PRODUCT CHANGE NOTIFICATION

Bourns® Model SRU6025A Series Shielded Power Inductors *Manufacturing Process Change*

Riverside, California – September 14, 2021 – Effective December 4, 2021, Bourns will change the manufacturing process of the [Model SRU6025A Series Shielded Power Inductors](#) from a manual process to an automated process. This process change should improve production efficiency, product quality and reliability.

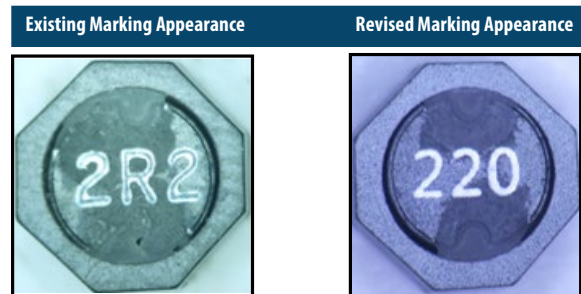
Existing Manufacturing Process	Revised Manufacturing Process
1. Manual gluing	1. Automated gluing
2. Manual ink marking	2. Stencil ink printing
3. Manual testing & taping	3. Automated & integrated testing/taping

The form of the inductor will change due to the change in the marking method. The fit and function will remain the same. The quality and reliability should be improved as the result of the manufacturing process change.
